AREA C - ADDENDUM #1

Date:	12.23.2015	Addendum No:	Area "C" – Addm #1
Project:	York General Health Care Services Hospital Addition And Remodel	Project No:	24902
To:	Jake Kulhanek	Firm:	Sampson

THIS ADDENDUM IS ISSUED BY THE ARCHITECT TO ALL PARTIES WHO HAVE RECEIVED BIDDING DOCUMENTS FOR THE ABOVE LISTED PROJECT. THIS ADDENDUM SHALL BECOME PART OF THE CONTRACT DOCUMENTS AS A REVISION TO THE ORIGINAL DOCUMENTS.

6 FRAMING DETAIL
3/4" = 1'-0"

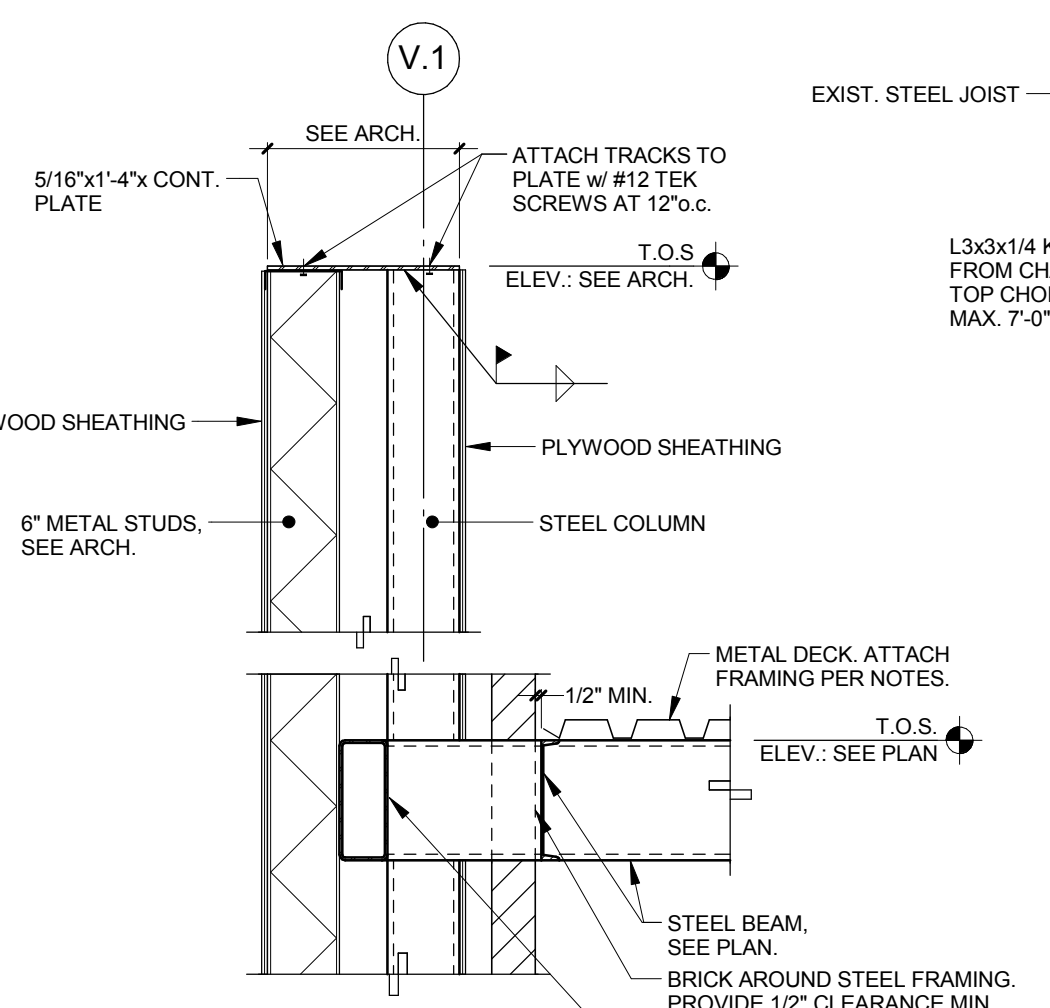
1. Sheet S1-0, STRUCTURAL NOTES / DETAILS. (Reissue in its entirety):
 - a. Revised the jamb stud required for openings above 7'-0" in Detail 6.
2. Sheet S1-1, FOUNDATION & FLR FRAMING / DETAILS AREA A. (Reissue in its entirety):

HANGING EQUIPMENT FRAMING NOTES: (DETAILS 20 & 21)

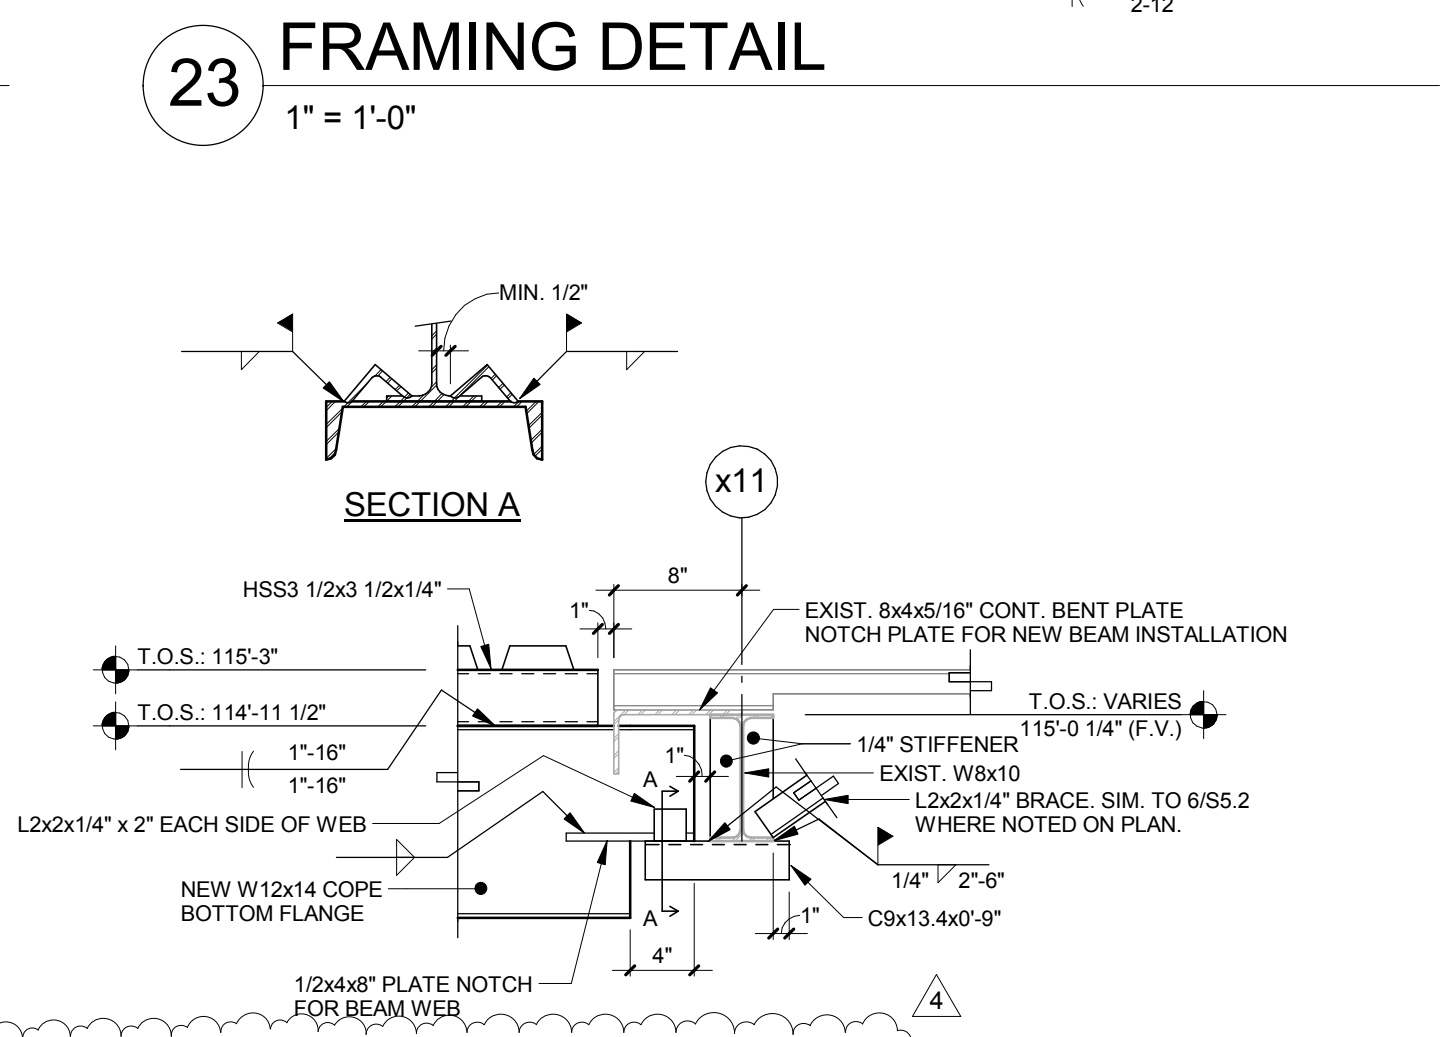
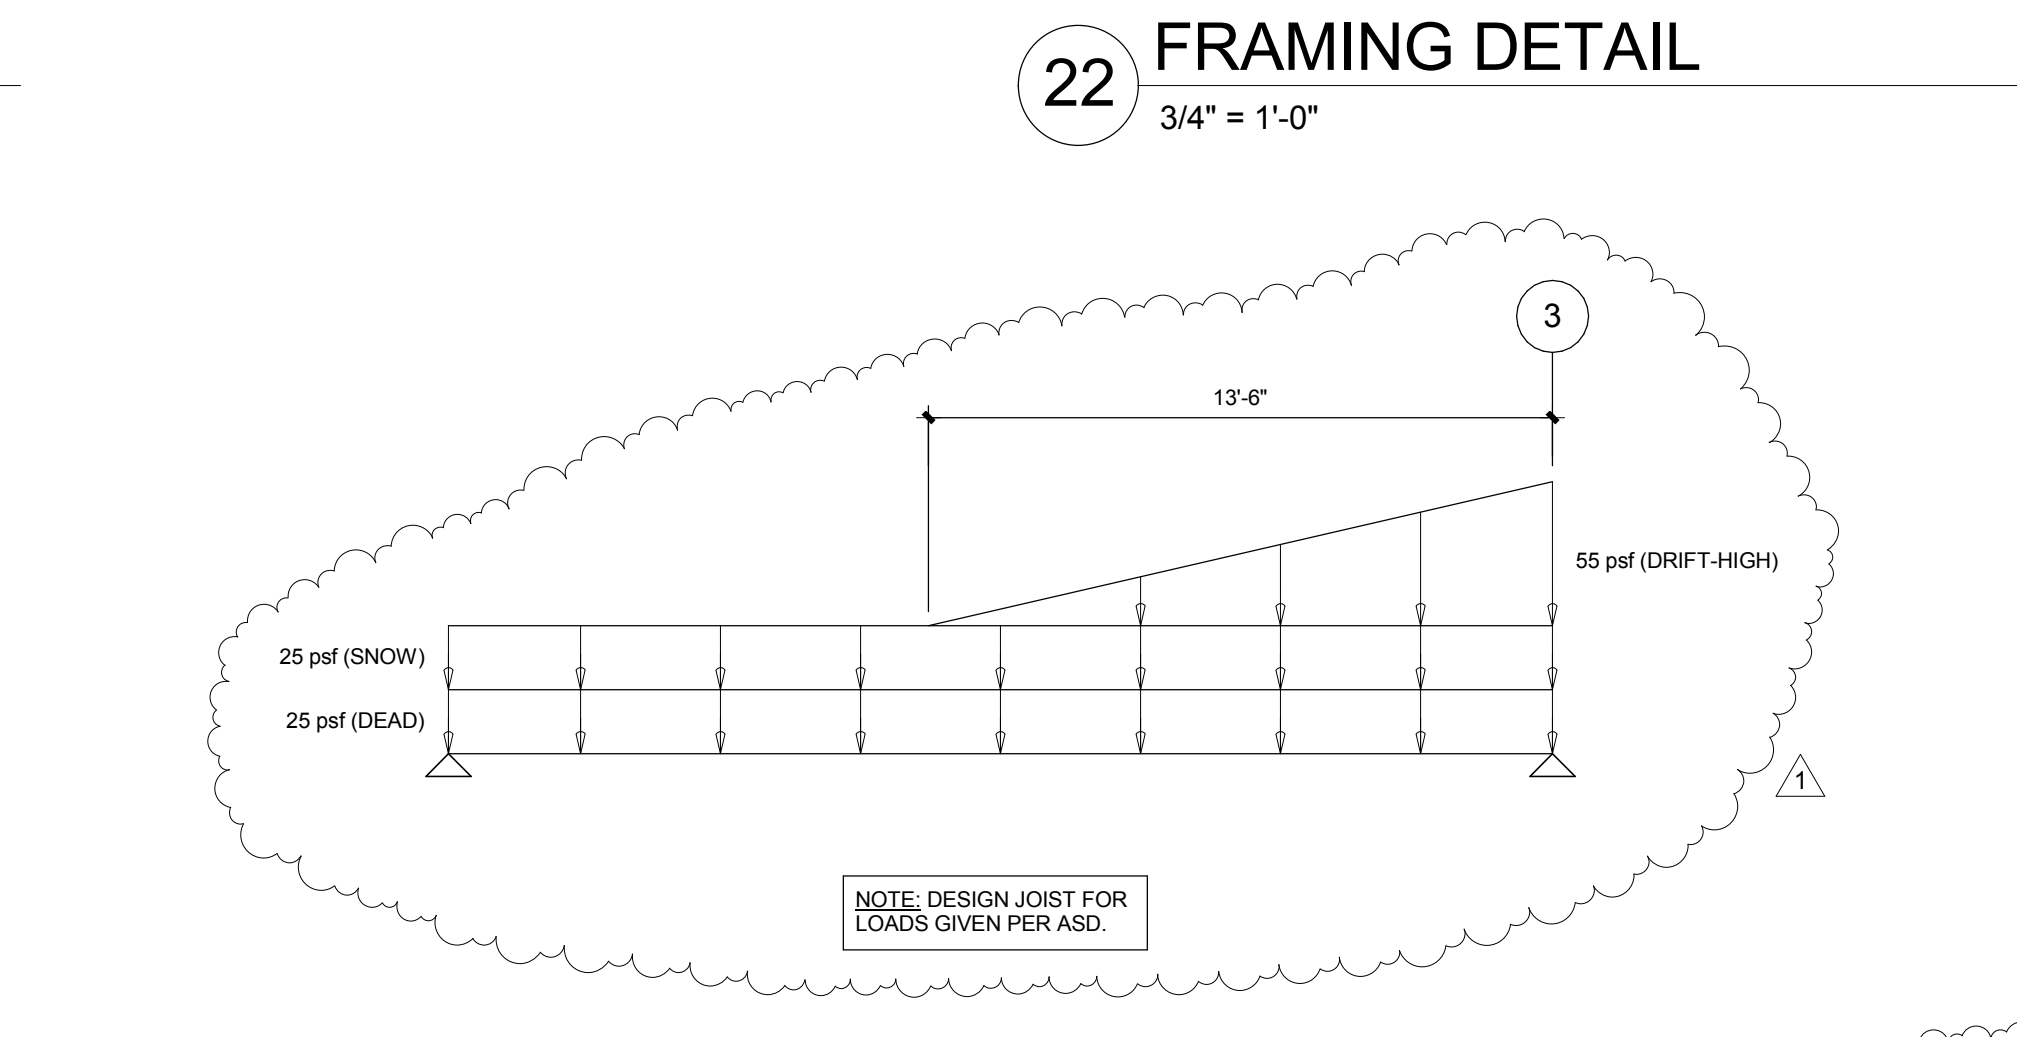
4. Sheet S5-3, STRUCTURAL DETAILS. (Reissue in its entirety):
 - a. Added notes to Detail 20 & 21 for optional equivalent steel framing sections to the unistrut shown. Framing member's selection is contractor's option.

Sheet Number:
S5-3

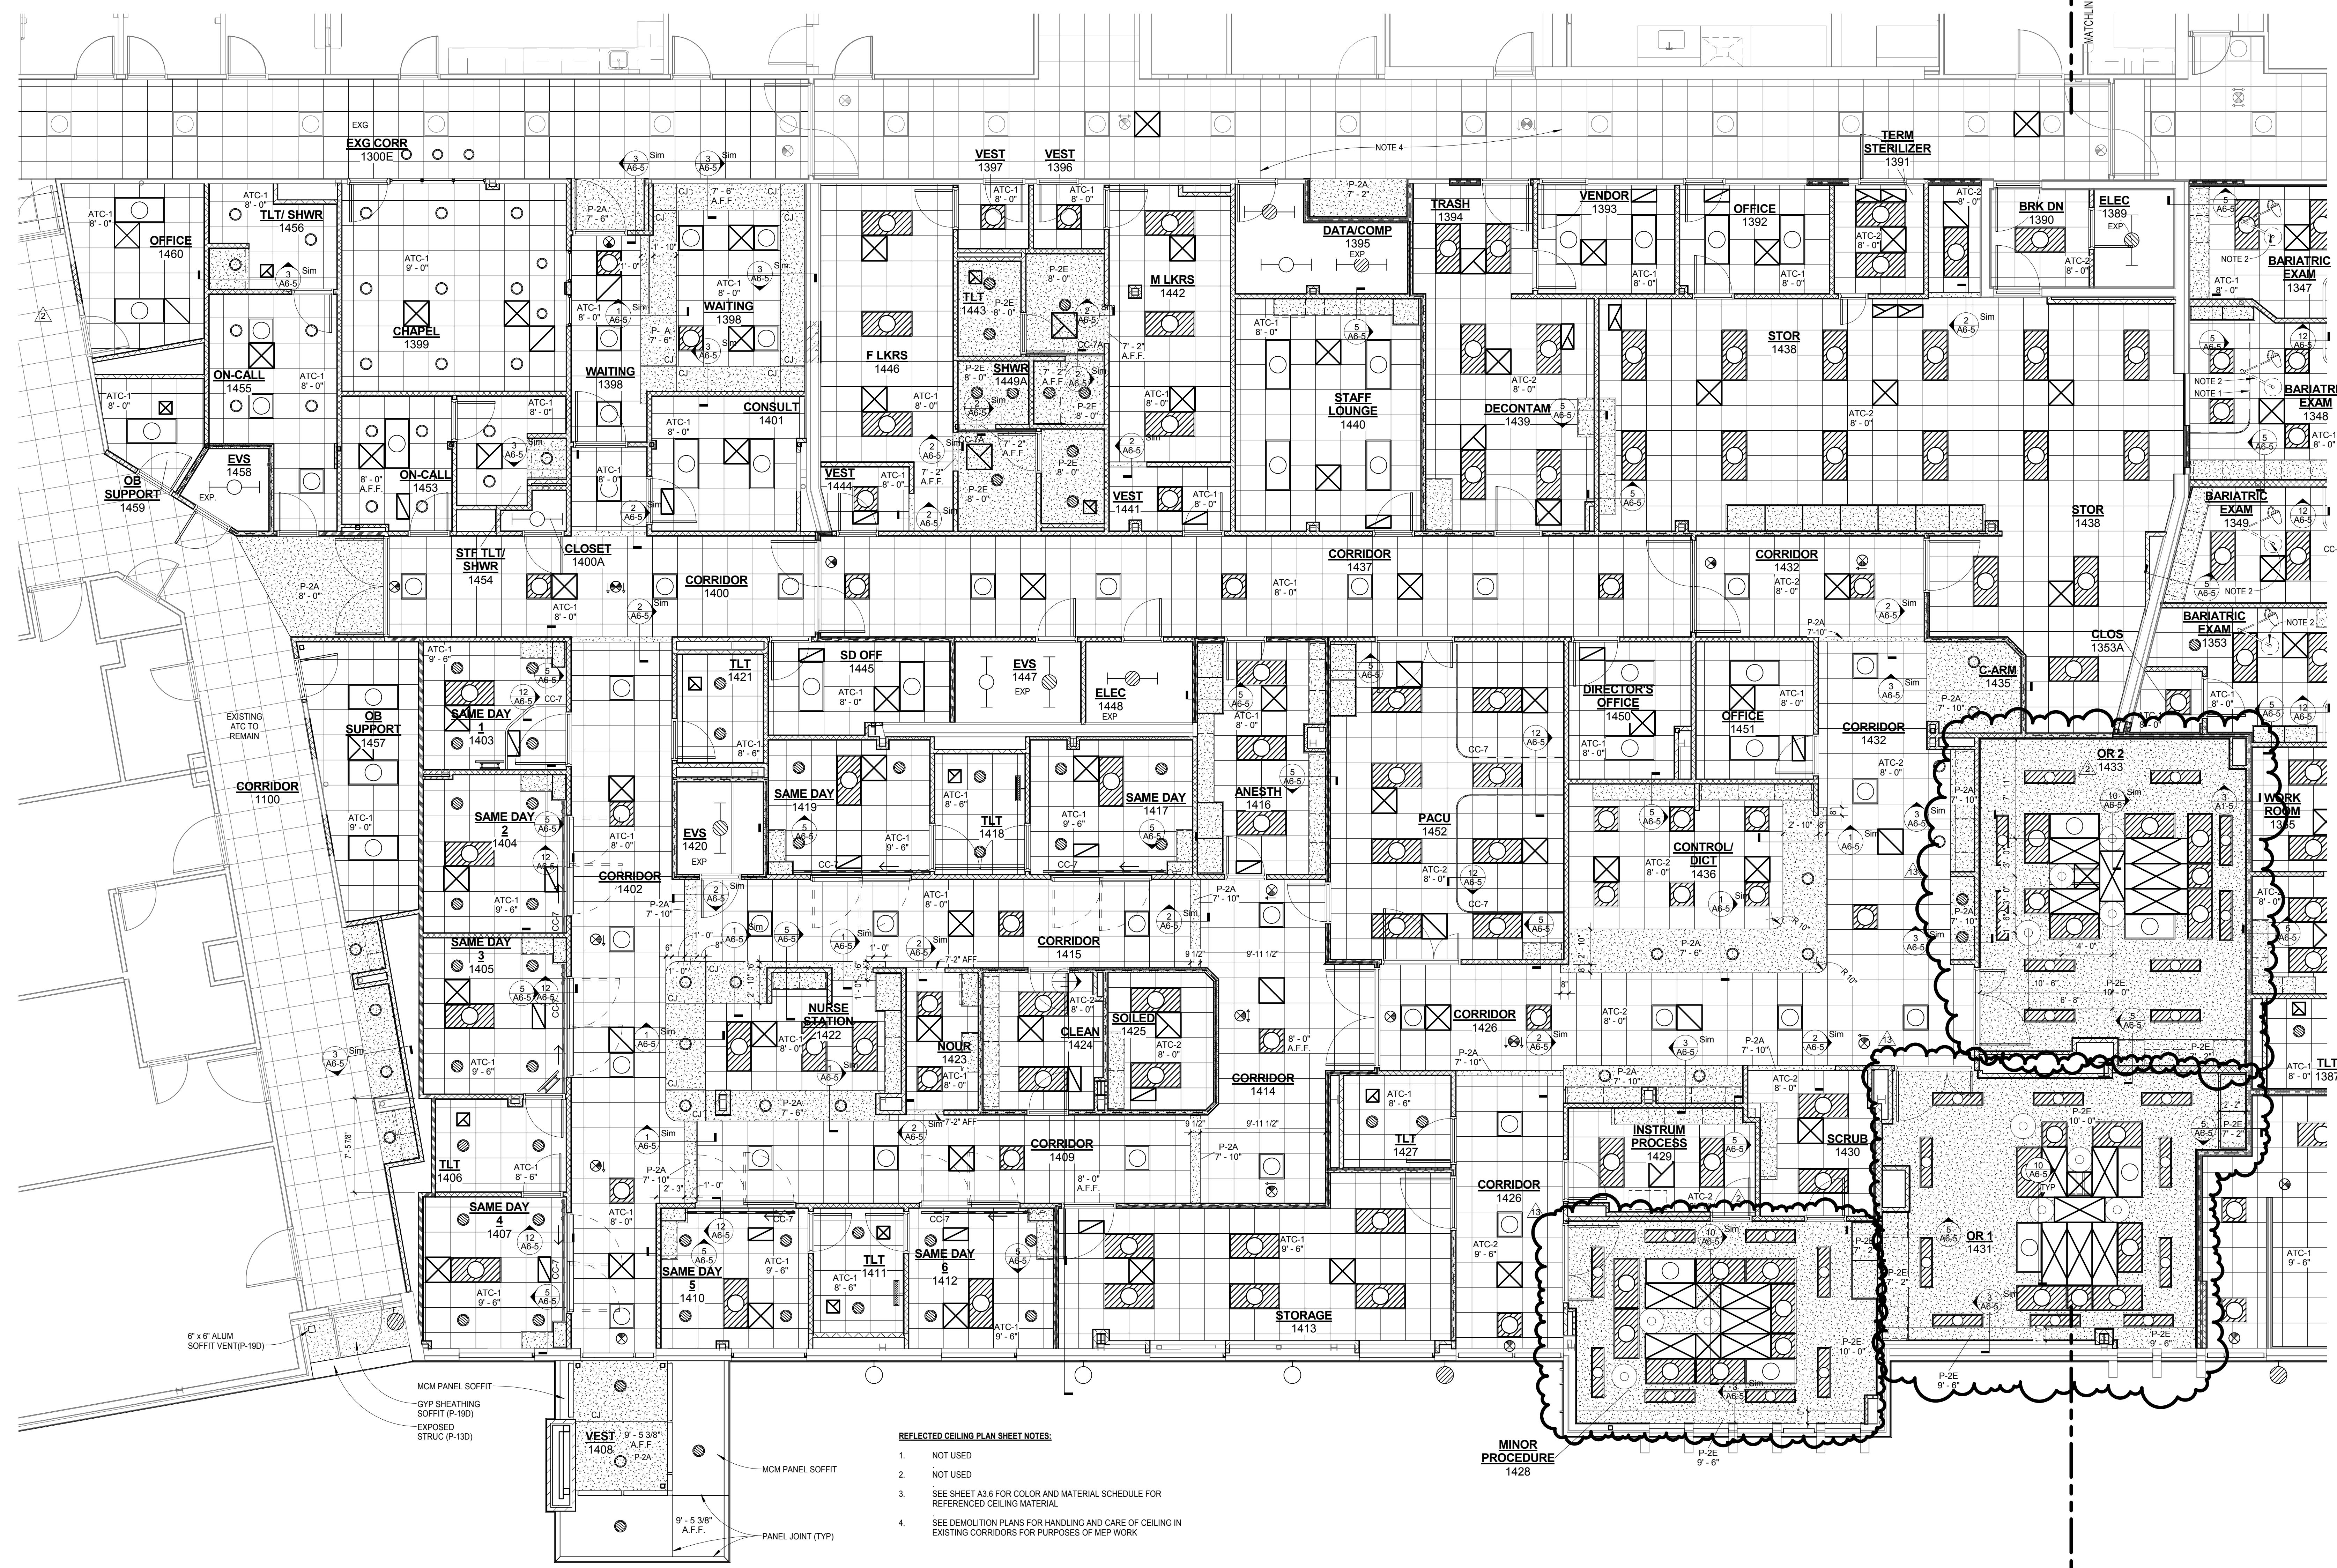
- b. Added detail 24, a loading diagram for the "14KSP1" joists called out on S1-7. No new joists were added and no modifications to current framing were made. The joist in question already appears on the plans.

1 CEILING PLAN LEVEL 1 - AREA C
A6-3 3/16" = 1'-0"

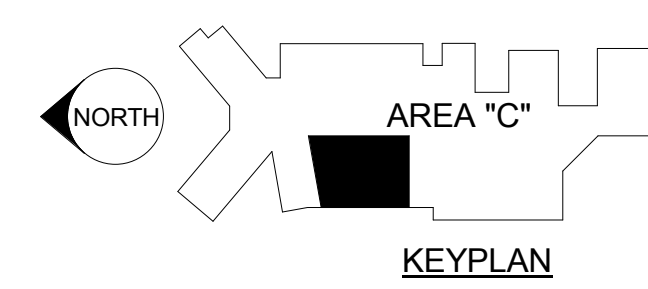
6. Sheet A6-3, REFLECTED CEILING PLAN – AREA C (Reissue in its entirety):

a. Revised OR ceiling plans
